PROJECT:  
20A DEANE STREE, COTTESLOE 6011  
DRAWING TITLE:  
SITE PLAN  
CLIENT: J STEWART + N STEWART

# Proposed Dwelling and Associated Crossover

Submission from Residents of upper Deane Street opposing proposed plans for two storey dwelling on 20A Deane Street.

PROJECT: 20A DEANE STREET, COTTESLOE 6011	DRAWING NUMBER <b>DA02</b>	REVISION <b>D</b>
DRAWING TITLE: BASEMENT FLOOR PLAN	31/08/2020	1:100 @ A2
CLIENT: J STEWART + N STEWART

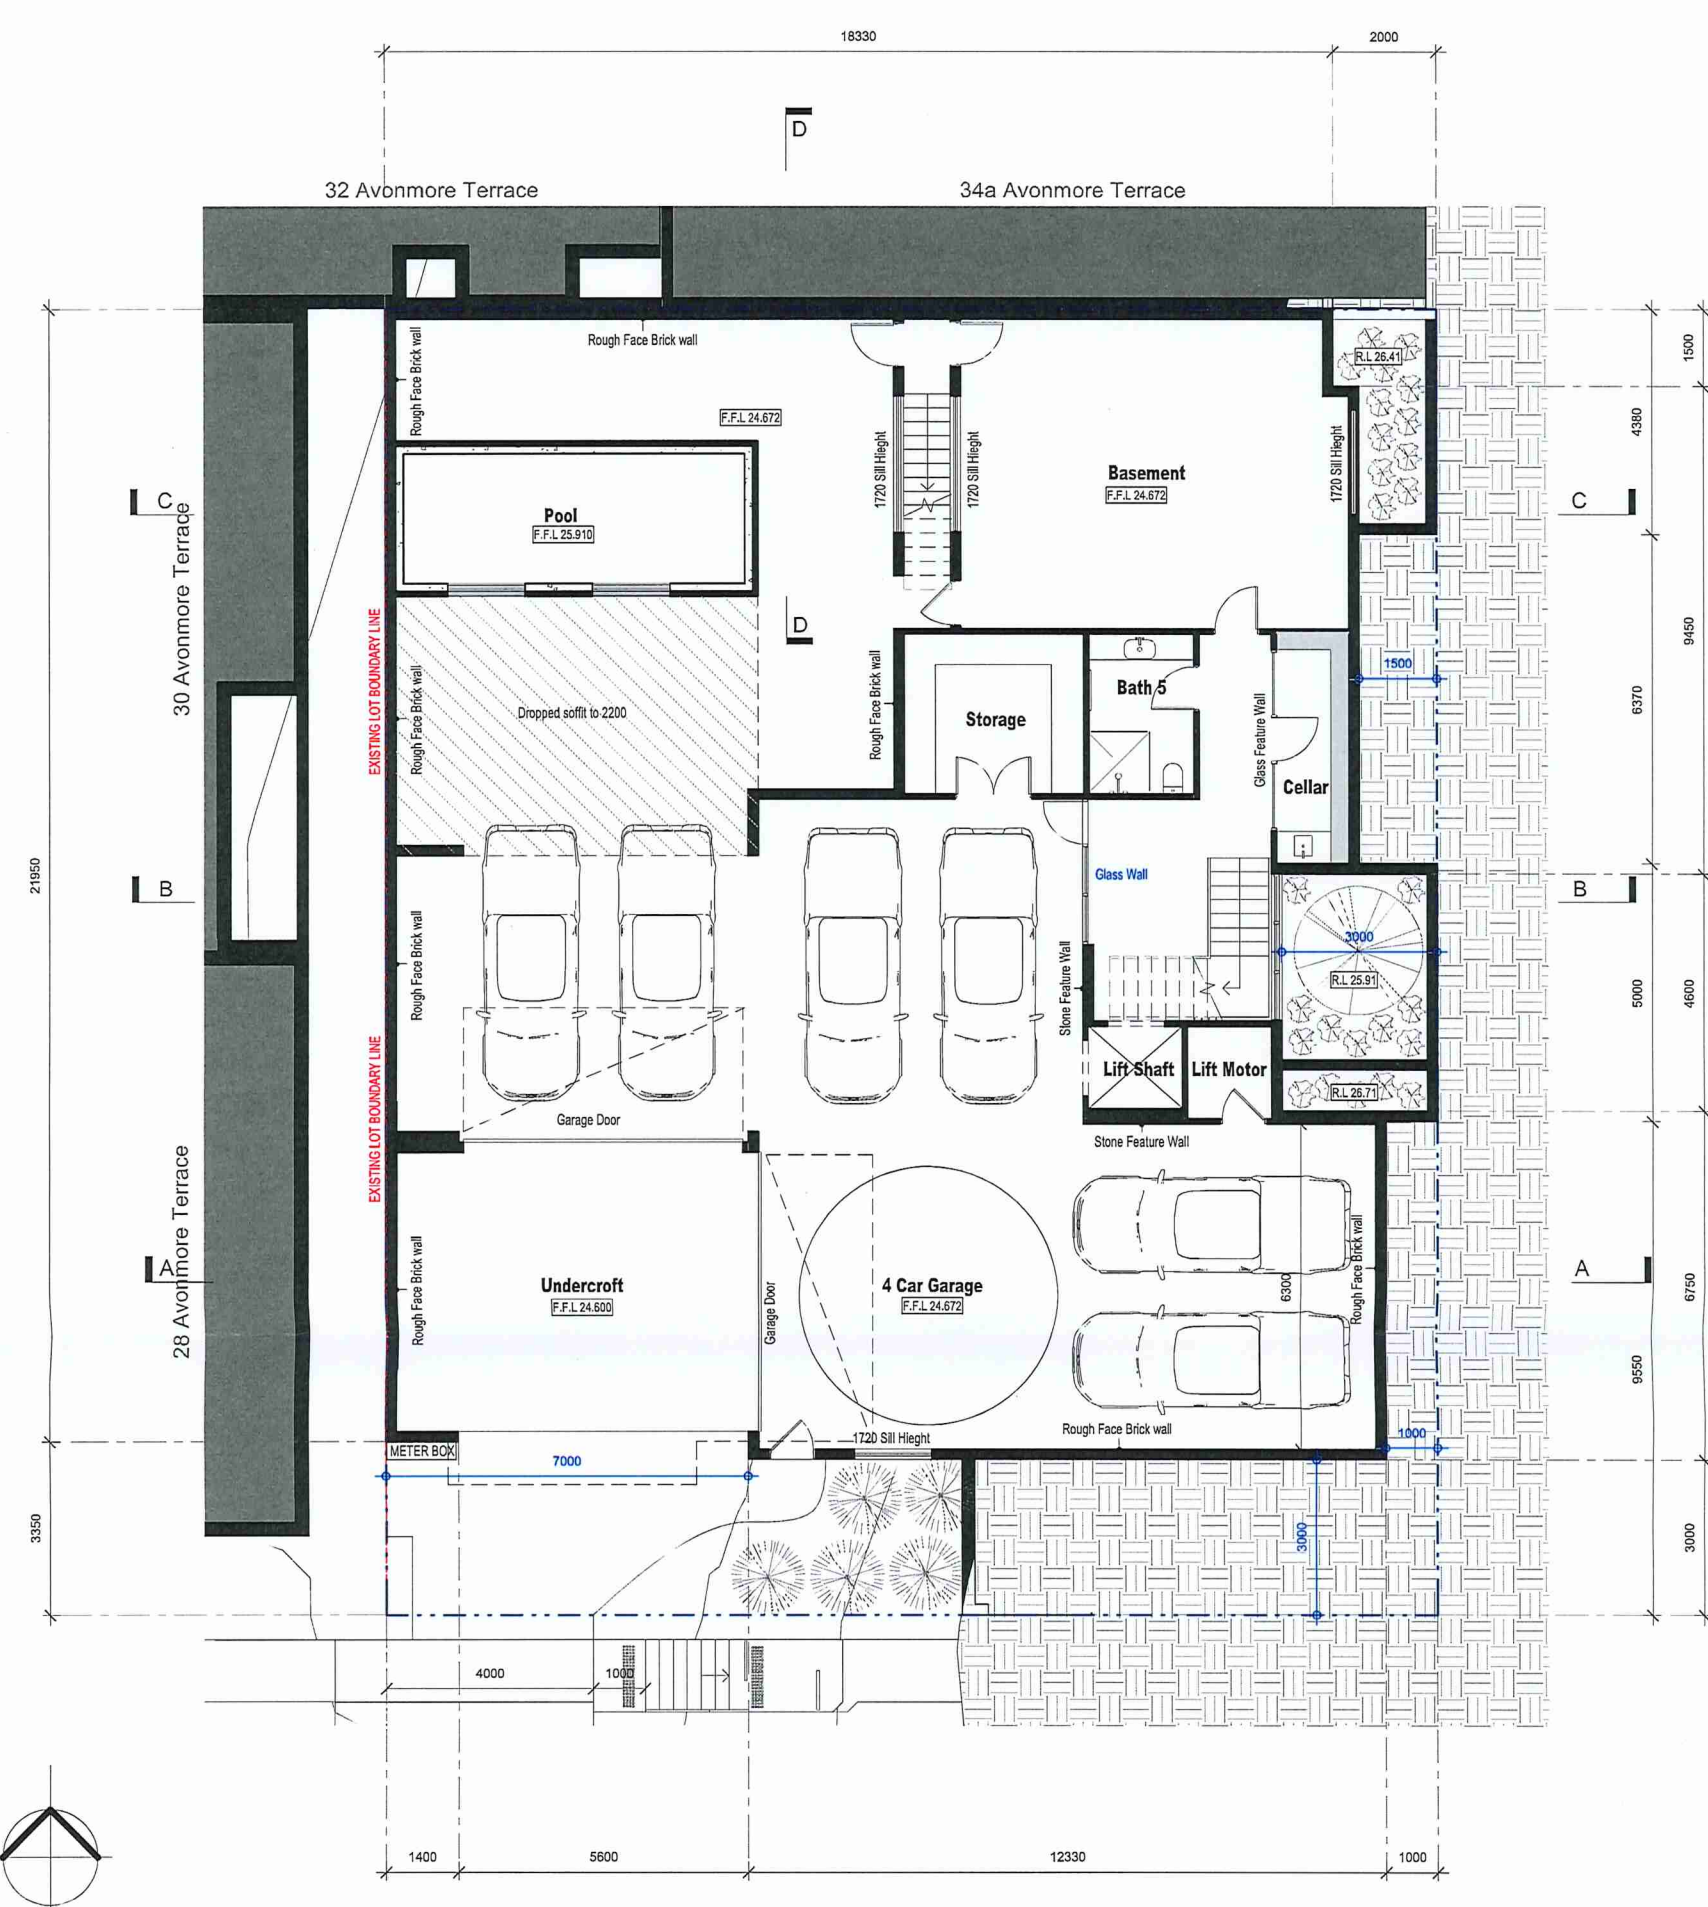
Further, it is requested that the proposed finished levels of the proposed crossover and upper landing to the staircase are shown on the Basement Floor Plan (ref. DA02) and the Ground Floor Plan (ref. DA03). Currently, the plans lack this information and an assessment of the actual finished levels of the public space cannot be undertaken.

**ANNOTATED CONTOUR  
INTERPOLATION PLAN  
(WHELANS, 2 DECEMBER 2014)**

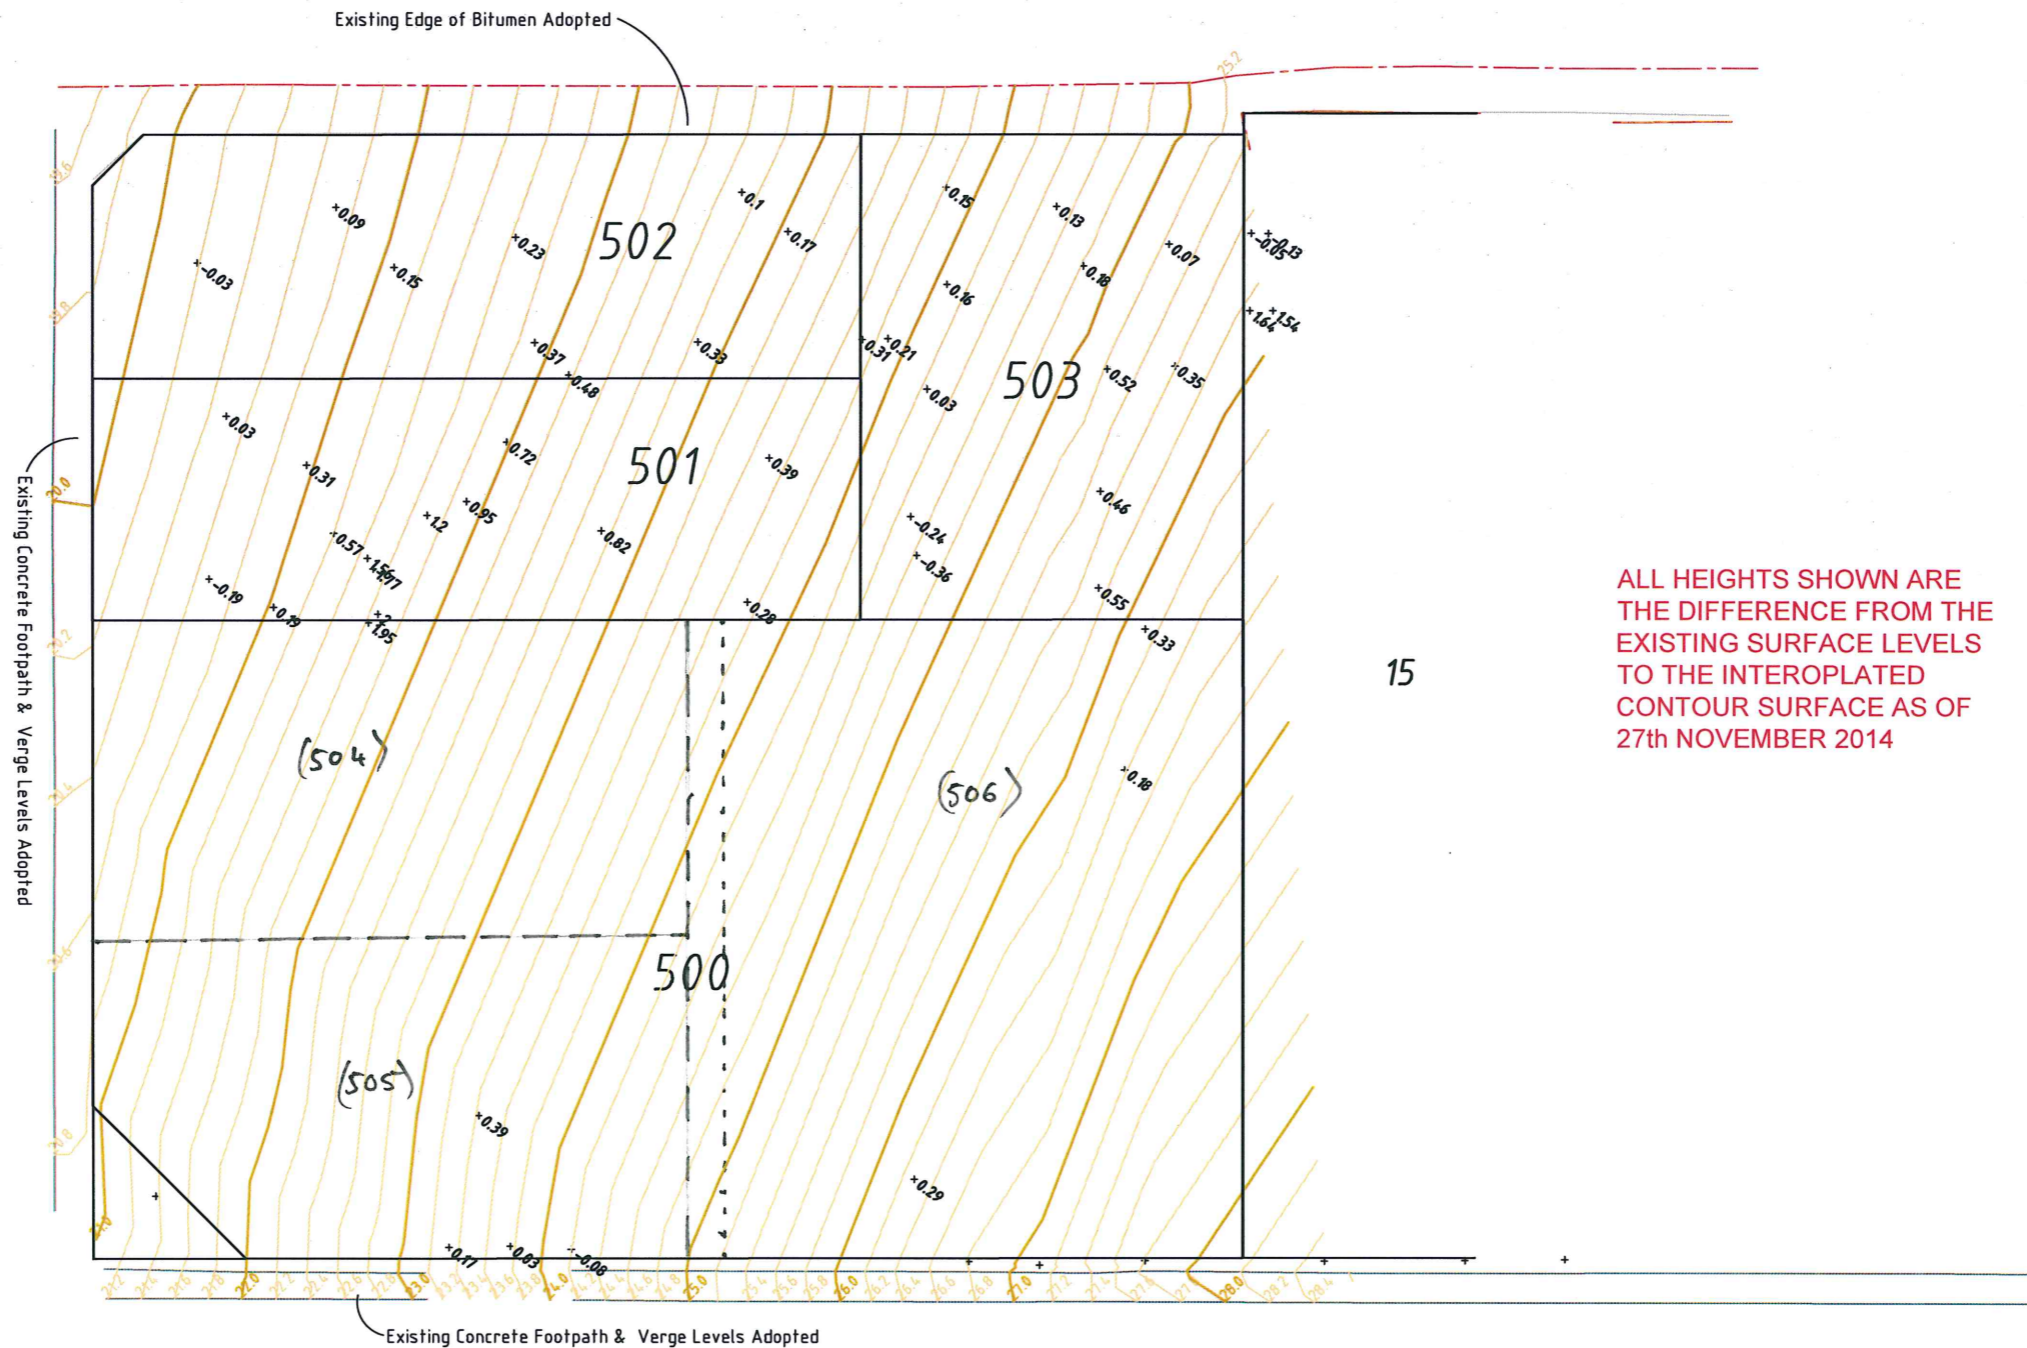
A copy of the Whelans contour interpolation plan has been provided at **Attachment 2** and has been annotated to provide the approximate boundaries of Lots 504, 505 and 506.

We understand that the Whelans contour interpolation plan provides for an accurate representation of the original NGLs across the superlot (inclusive of the subject site at Lot 506) and is an appropriate benchmark for assessment of building heights, particularly given the extent of excavation which has occurred at the subject site following the demolition of the existing dwelling in early 2015.

**ANNOTATED ROOF PLAN DA05**  
**(31 AUGUST 2020)**

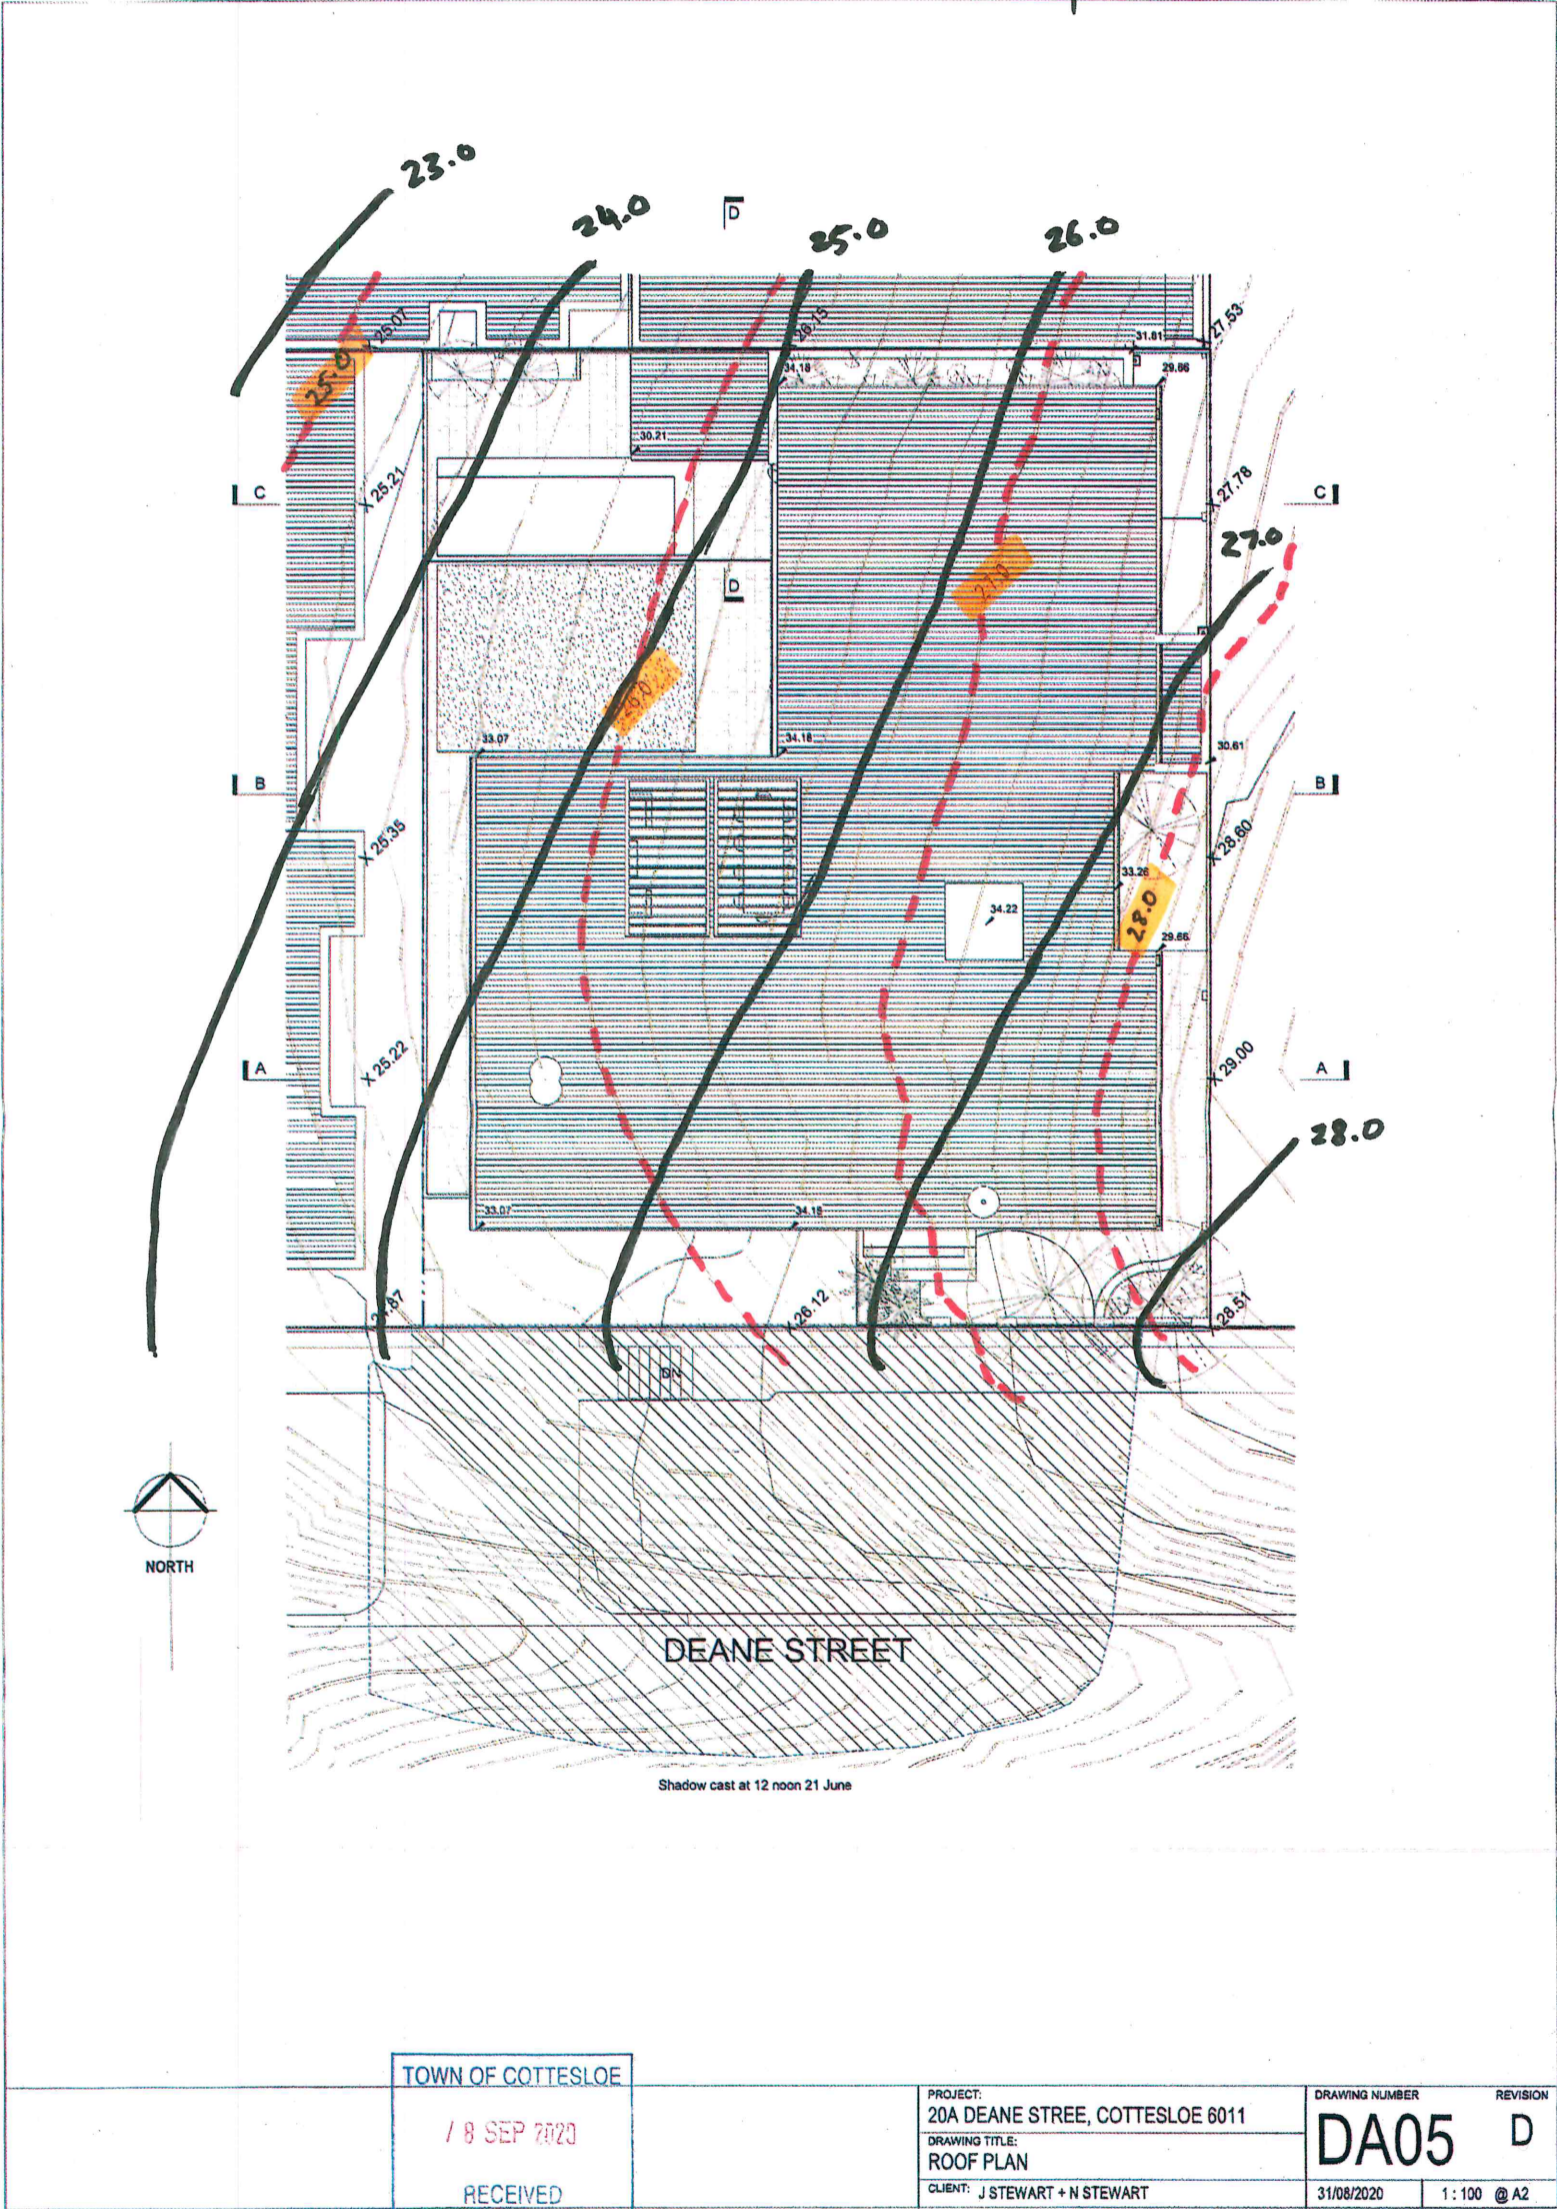
We note that the Roof Plan (ref. DA05) for the proposed dwelling at the subject site has included contours across the site. A comparison has been undertaken between the approved Whelans contour interpolation plan and the proposed Roof Plan (ref. DA05) to determine whether the contour levels are consistent across the plans. As demonstrated in **Attachment 3**, significant variations exist between the interpolated contour levels provided

on the Whelans plan compared with the Roof Plan (ref. DA05). In some areas of the site, differences of up to 1.0m to 1.5m have been identified which would result in substantial height allowances for the current proposal if the development was approved using the contours shown on the Roof Plan (ref. DA05).

It appears, based on the sketch plan at **Attachment 3**, that if the dwelling was assessed using the Whelans contour interpolation plan, it is likely that the building would exceed the building height limits under LPS3.

As demonstrated above, no discretion exists under LPS3 to consider variations to building height. With respect to the calculation of building height in this instance, neither the Town, nor the public appear to have the correct information before them to make an assessment of the proposal under the LPS3 provisions.

We request that prior to the application being determined, amended plans be provided by the applicant and the proposal readvertised for public comment to allow for an accurate assessment of building height to occur.
